FILE: MSL-0003-00(165) Douglas
P.I. No. 0003165
I-20 HOV from Bright Star Rd. to S.R. 6

**SUBJECT: IMPLEMENTATION OF VALUE ENGINEERING STUDY
ALTERNATIVES**

Value Engineering Study Response

**GDOT PROJECT MSL-0003-00(165)
I-20W HOV LANES FROM BRIGHT STAR ROAD TO
SR 6/THORNTON ROAD**

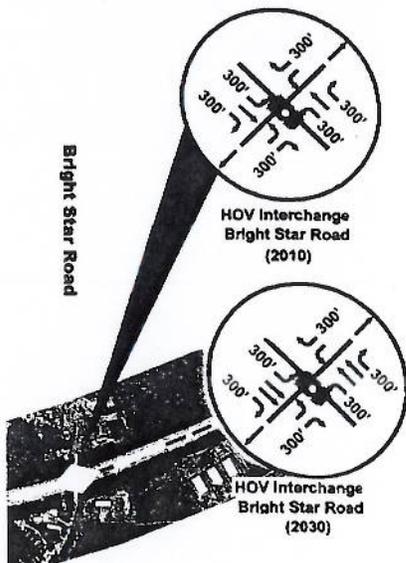
Project:	HOV LANES ON I-20 WESTSIDE FROM BRIGHT STAR ROAD TO SR6/THORNTON ROAD <i>Georgia Department of Transportation</i>	Alternate No.: 1
Description:	DO NOT BUILD BRIDGE AT BRIGHT STAR ROAD TO ITS ULTIMATE WIDTH	
Original Design:	The original design is to build the Bright Star Road Bridge over I-20 four lanes wide to accommodate design year traffic.	
Alternative:	Build a two-lane bridge at this time to match the two-lane roadway. Widen the bridge at the same time the roadway is widened. Construct the bridge to accommodate future widening.	
Advantages:	<ul style="list-style-type: none">• Saves bridge cost now• Future widening may not be necessary• Not needed for the immediate future	
Disadvantages:	<ul style="list-style-type: none">• The cost of the bridge will increase in the future	
Discussion:	Build only what is needed to accommodate opening day traffic. Upgrades can be completed when needed at a later date.

We agree with the Value Engineering recommendation to accommodate opening day traffic. However, the opening day traffic (2010) for the Bright Star Road Bridge requires a five (5) lane bridge. The layout is as follows: One shared left turn lane in the center of the bridge and two through lanes in each direction.

This bridge configuration meets the build year (2010) recommendation. The design year (2030) recommendation is for a seven (7) lane bridge as seen in the figure below.

Our recommendation is to build only what is needed for opening day traffic which is a five lane bridge. If needed in the future this bridge can be widened.

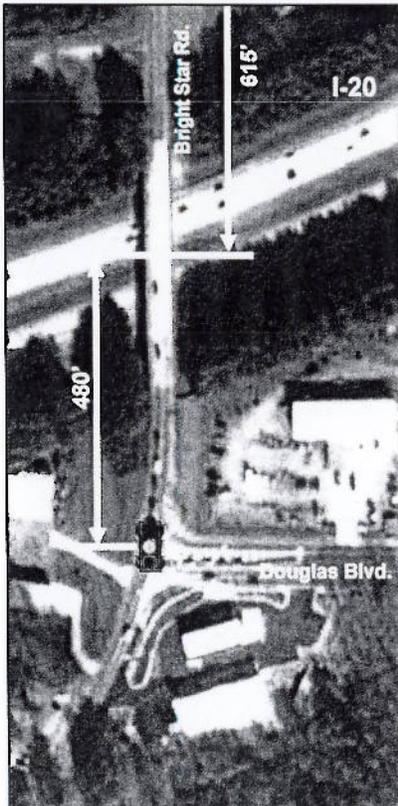
Project:	HOV LANES ON I-20 WESTSIDE FROM BRIGHT STAR ROAD TO SR6/THORNTON ROAD <i>Georgia Department of Transportation</i>	Alternate No.: 3
Description:	DO NOT BUILD DIVERSION OF DOUGLAS ROAD AT BRIGHT STAR ROAD	
Original Design:	The current design shows the intersection of Douglas Road and Bright Star Road relocated 600 ft. south of its current location due to the Bright Star Road bridge being raised approximately 5 ft. over I-20. Approximately 1,700 linear ft. of Douglas Road will be relocated.	
Alternative:	Keep Douglas Road in its current location. Tie Bright Star Road to meet its existing profile as soon as possible. The existing intersection is 300 ft. south of bridge. Assume at least 2 ft. of the 5-ft. elevation difference can be made up. Reconstruct Douglas road to tie into Bright Star Road at its proposed elevation.	
Advantages:	Disadvantages:	
<ul style="list-style-type: none"> ● Reduces reconstruction ● Reduces right-of-way costs/takes 	<ul style="list-style-type: none"> ● None apparent

Discussion:	The diversion of Douglas Road can be avoided by adjusting the proposed profile of Bright Star Road to meet the existing road profile sooner. This will reduce the amount of grade adjustment necessary on Douglas Road at Bright Star Road and save significant cost.

The current location of the intersection of Bright Star Road and Douglas Boulevard is 480 feet from the proposed HOV ramps at Bright Star Road. Geometrically it is possible to tie the profile at the new bridge over I-20 with the existing ground before Douglas Boulevard. The concern with this intersection is how it will perform operationally due to the close in proximity to the proposed ramps and the high traffic volumes.

The traffic study recommends dual left turn lanes onto Douglas Boulevard with a minimum of 450 feet of storage, or 820 feet for a single left turn lane. The existing intersection is only 480 feet from the ramps (Appendix A, Figure 1). Storage is also needed on the bridge to accommodate left turns onto I-20 West, thus there would be an overlap of storage space.

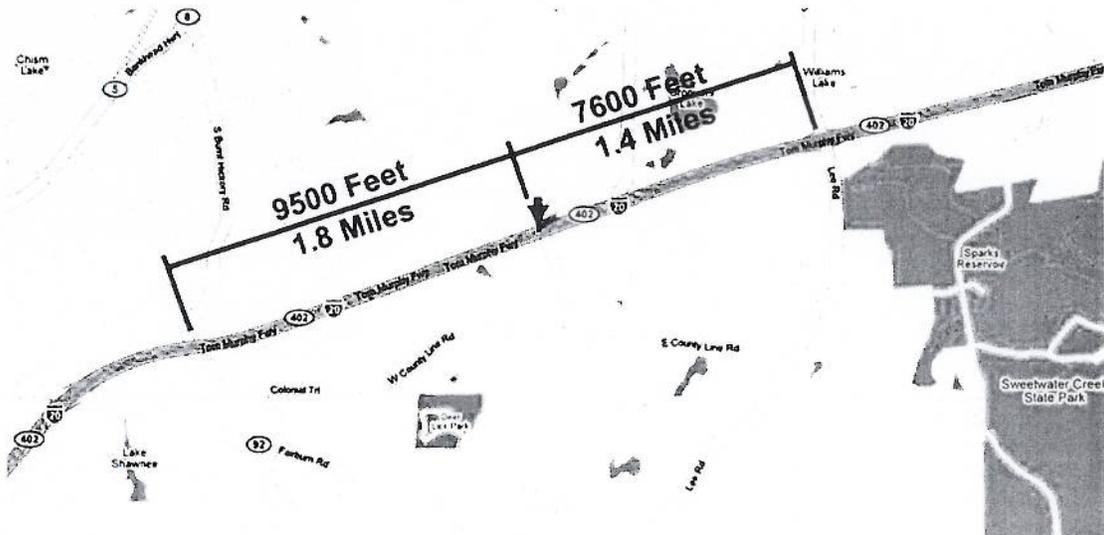
Project:	HOV LANES ON I-20 WESTSIDE FROM BRIGHT STAR ROAD TO SR6/THORNTON ROAD <i>Georgia Department of Transportation</i>	Alternate No.: 9
Description:	CUL-DE-SAC NORTH COUNTY LINE ROAD	
Original Design:	The existing bridge for North County Line Road over I-20 will be replaced due to the addition of HOV lanes along I-20	
Alternative:	Cul-de-sac North County Line Road on either side of I-20 and remove the existing bridge.	
Advantages:	<ul style="list-style-type: none"> • Cost savings • Reduces right-of-way costs/takes 	Disadvantages: <ul style="list-style-type: none"> • Cuts off through traffic over I-20
Discussion:	Existing traffic north of I-20 can cross using Vulcan Drive or South Sweetwater to Lee Road or access Riley Road and/or McKnown Road to Burnt Hickory Road to cross over I-20. Existing traffic south of I-20 can cross using East County Line Road to Lee Road or West County Line road to Midway/Burnt Hickory Road.

The VE study recommends not replacing the bridge at North County Line Road over I-20 (location shown with an arrow below). Interstate 20 forms a natural barrier between the areas north and south of the highway. Because of this barrier there are limited locations to cross the Interstate.

The recommendation is to rebuild North County Line Road Bridge in its current location.

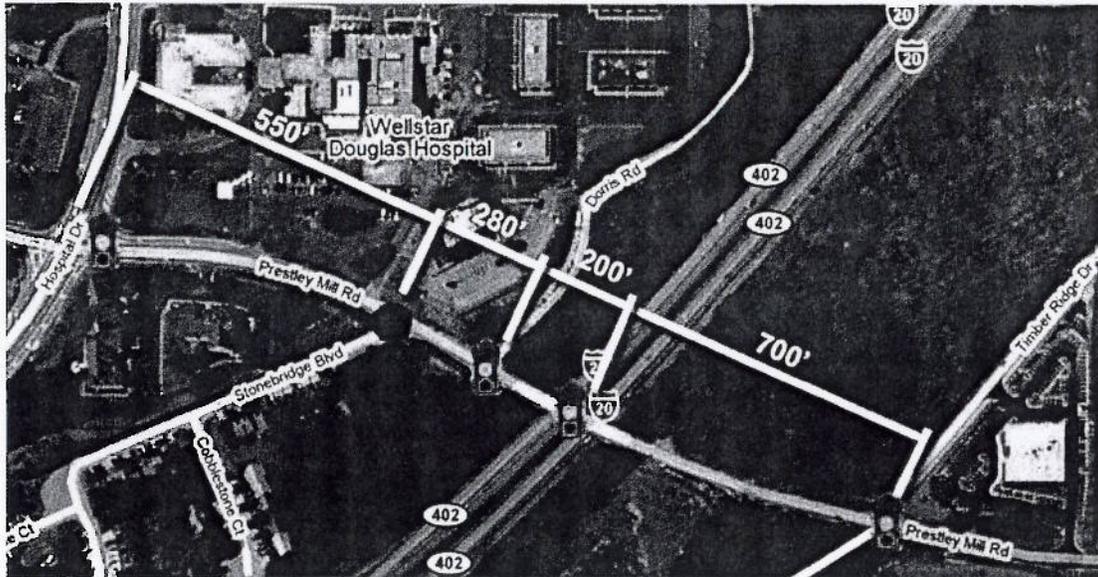
Project:	HOV LANES ON I-20 WESTSIDE FROM BRIGHT STAR ROAD TO SR6/THORNTON ROAD <i>Georgia Department of Transportation</i>	Alternate No.: 13
Description:	DEVELOP DORRIS ROAD FOR ACCESS TO DOUGLAS COUNTY MULTI-MODAL CENTER AND RELOCATE HOV INTERCHANGE TO PRESTLEY ROAD	
Original Design:	The concept design for the multi-modal facility indicates a four-lane divided road with curb and gutter and 10-ft. sidewalks. The multi-modal road will be designed and constructed on Dorris Road. Dorris Road will extend over I-20 with a new bridge and a full HOV-only, full drop ramp tying into Timber Ridge Drive. Timber Ridge Drive will be improved westwardly to the new Prestley Mill Road/Timber Ridge intersection.	
Alternative:	Develop Dorris Road on the north side of I-20 for the multi-modal center roadway. There exists a dirt road for access to Douglas County Hospital's property located in the southeastern section. Improve and upgrade the current intersection for Prestley Mill Road and Dorris Road to accommodate both HOV and single-occupancy vehicle/local traffic users. Right-of-way for this roadway could be sought from Douglas County Hospital as a donation to reduce cost for the purpose of the roadway improvement.

The option of converting Prestley Mill into an HOV interchange was originally considered in the Concept Alternate Report. Improving the dirt road between the Hospital property and I-20 was also considered as an alternate similar to what is described by the VE Study.

This alternative was dismissed for several reasons. The primary reason was the number of intersections along Prestley Mill Road. Adding an HOV interchange on I-20 and an intersection at Dorris Road would create four (4) intersections within 1180 feet of each other. The distance between the HOV ramps and the improved Dorris Road intersection would only be two hundred (200) feet. The projected traffic numbers along Prestley Mill Road indicated that these interchanges would not operate efficiently.

Our recommendation is that using Prestley Mill as an HOV interchange instead of at the Multi-Modal Center was not a viable option from the standpoint that it would not have worked operationally and would have required major impacts to a Doctor's office building and possible future office building.
